# FINAL DRAINAGE LETTER FOR LOT 2 CLAREMONT BUSINESS PARK 2 FILING NO. 2 EL PASO COUNTY, COLORADO

Project #10-025  
PCD Filing No.: PPR2345

**FINAL DRAINAGE LETTER FOR CLAREMONT  
BUSINESS PARK 2 FILING NO. 2  
EL PASO COUNTY COLORADO**

# INLET IN A SUMP OR SAG LOCATION

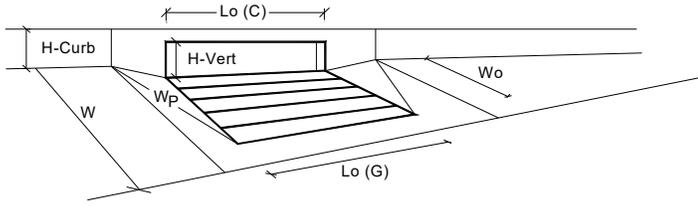
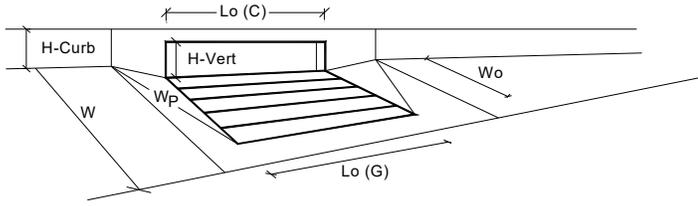
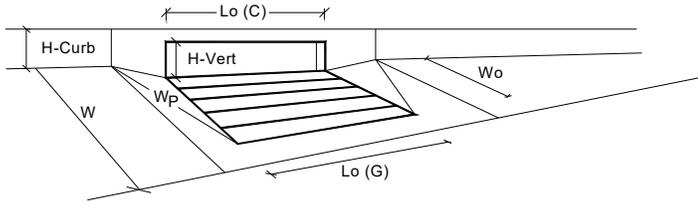
Please discuss the emergency pathway in case the sump inlet becomes clogged. This comment is applied to 2 proposed sump inlets.

Storm 3 - 100 yr

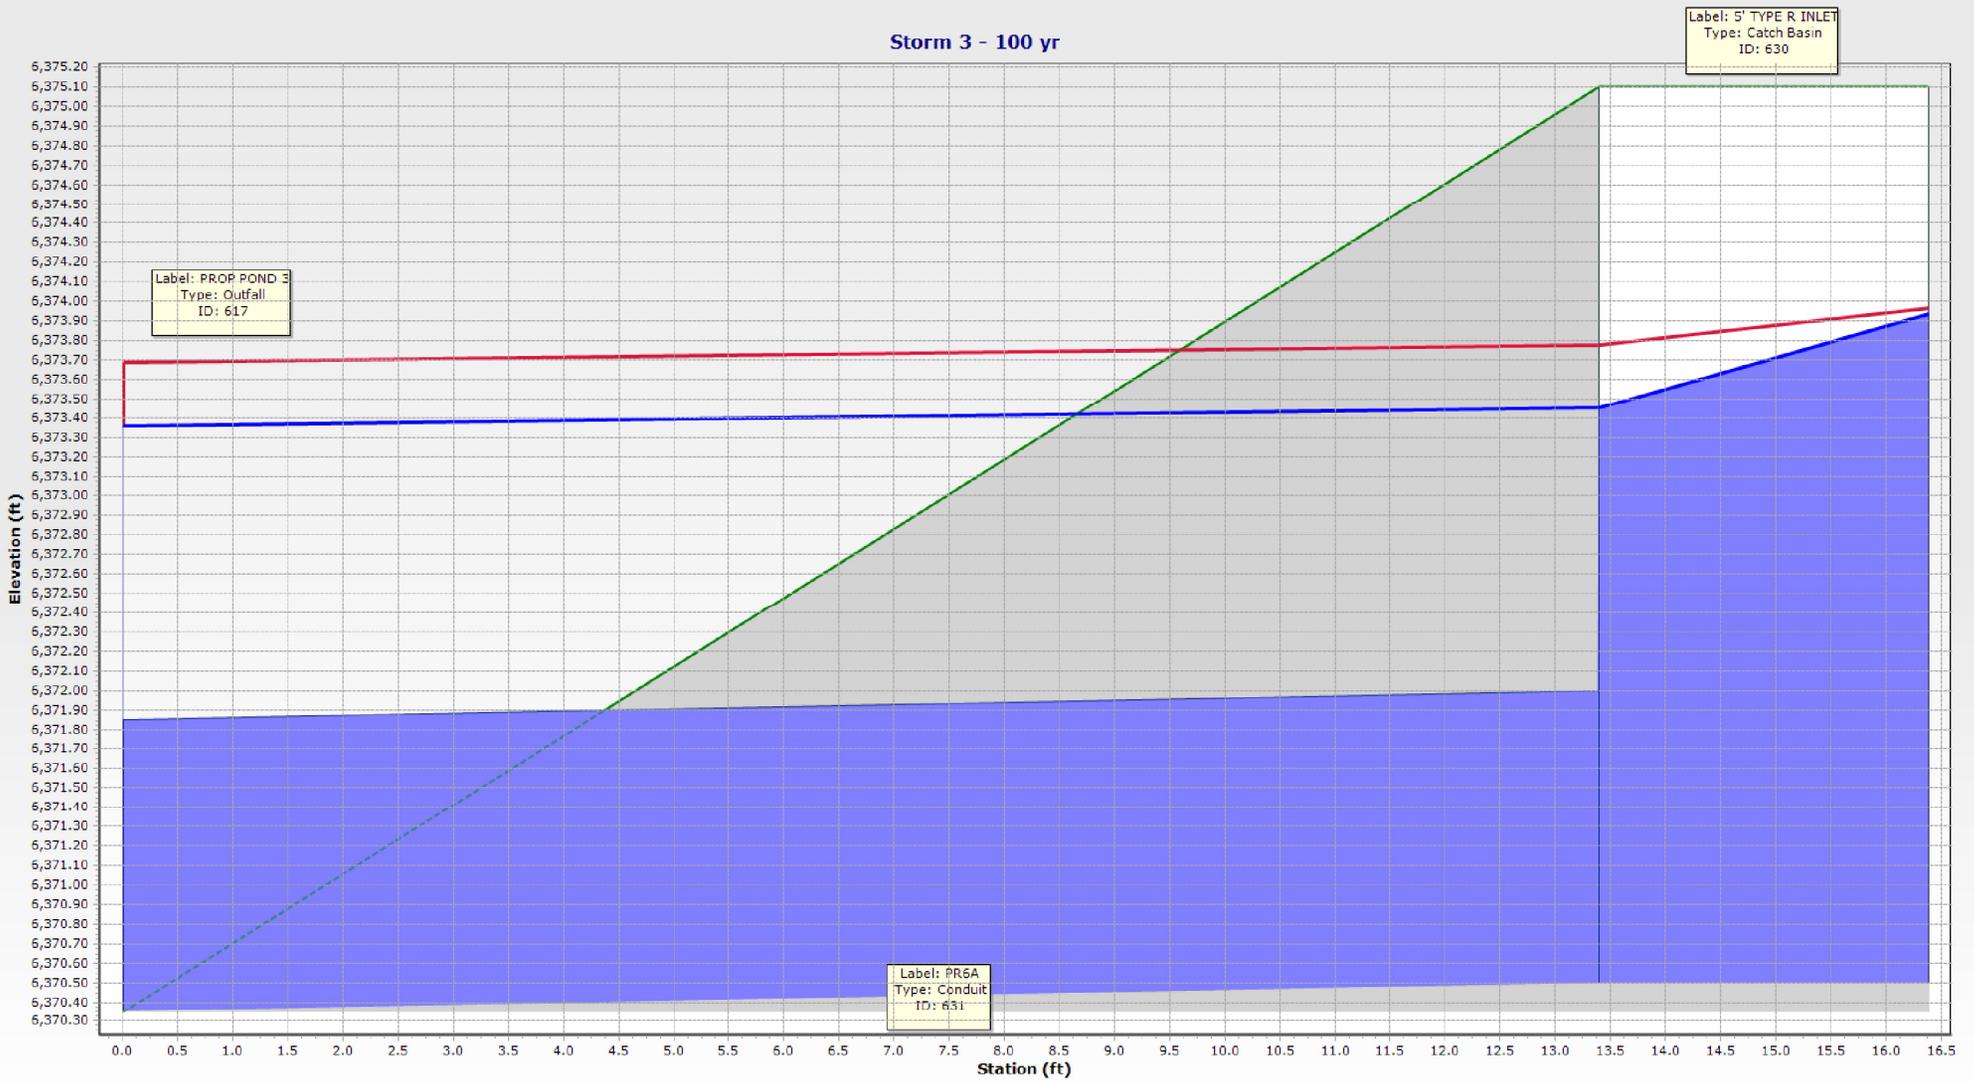
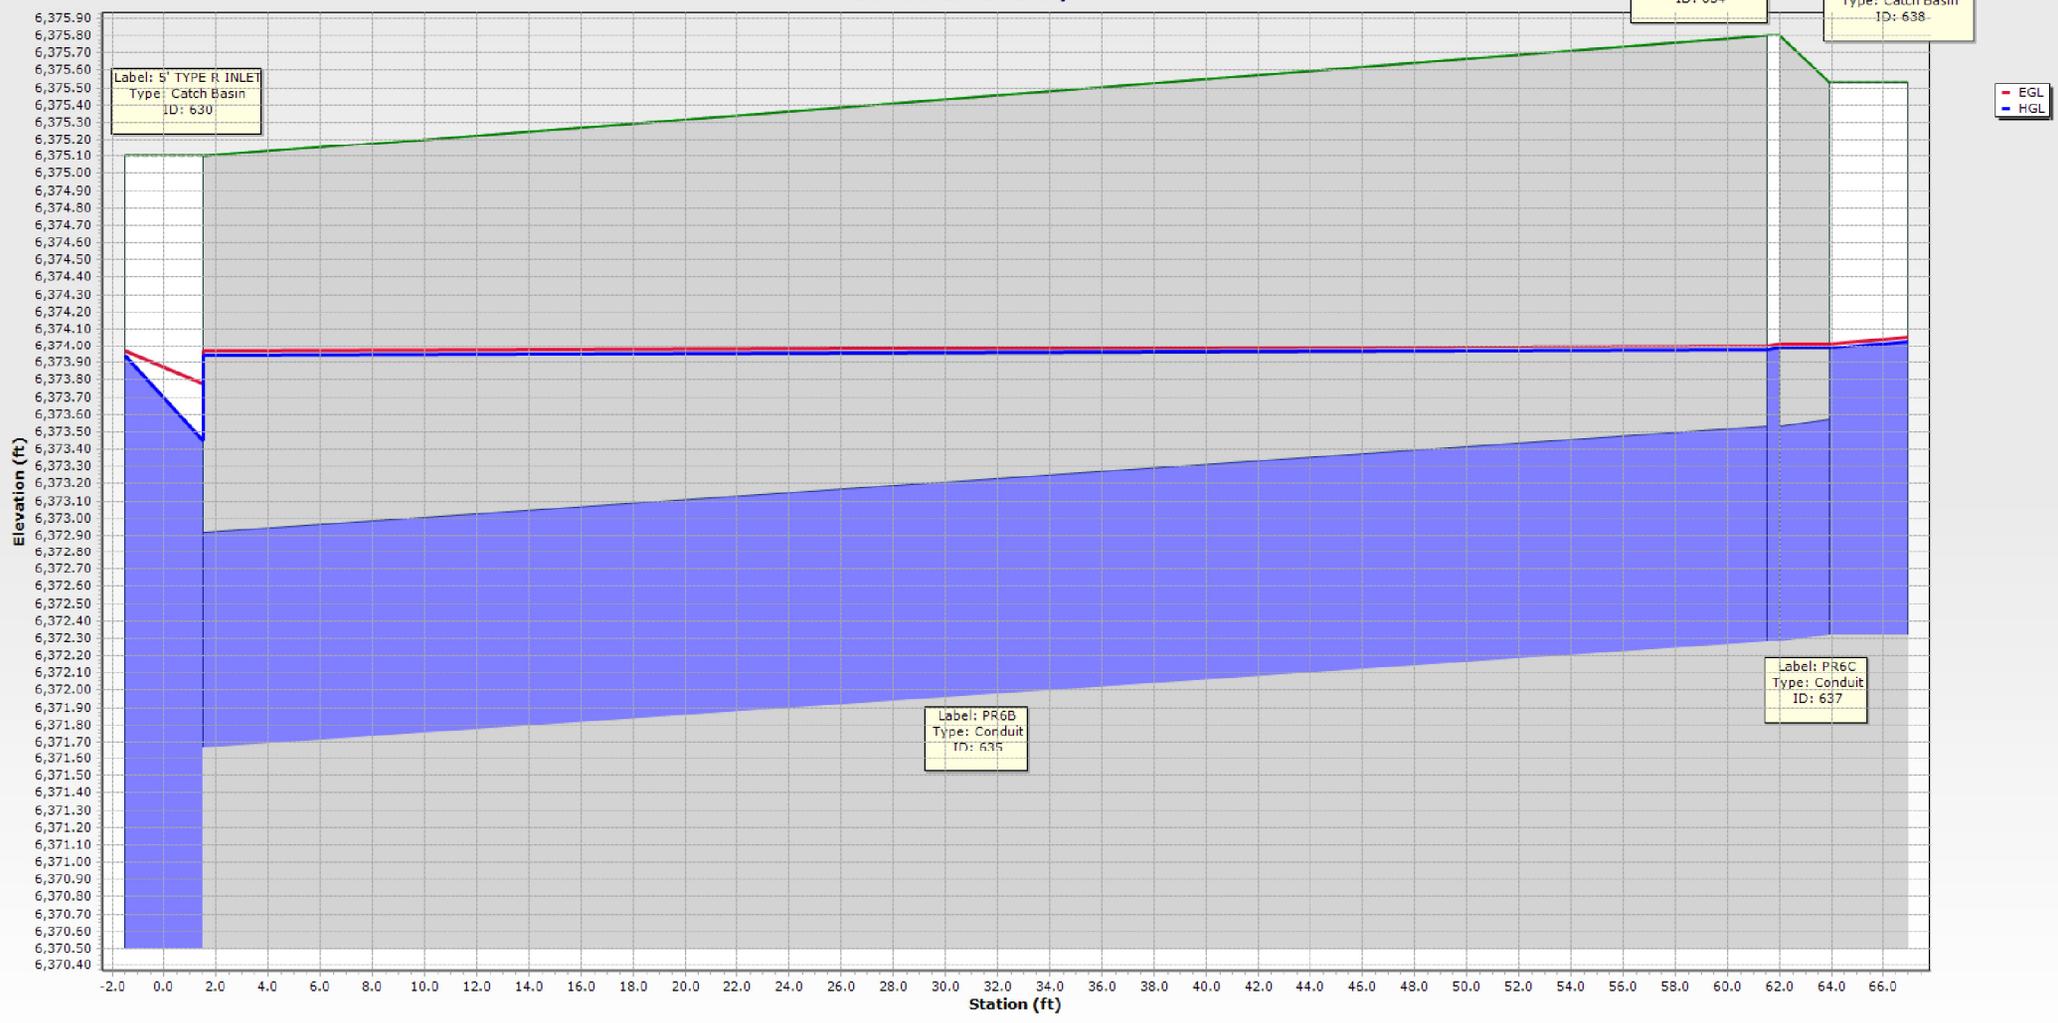
The drainage map and construction plan indicate that pipe 6A is an existing 18-inch pipe. Please revise accordingly.

The velocity is below the minimum requirement of 2.5 fps per ECM, Chapter 6, Section 6.3.3. Please revise.

Why is the slope negative? Please revise calculations.
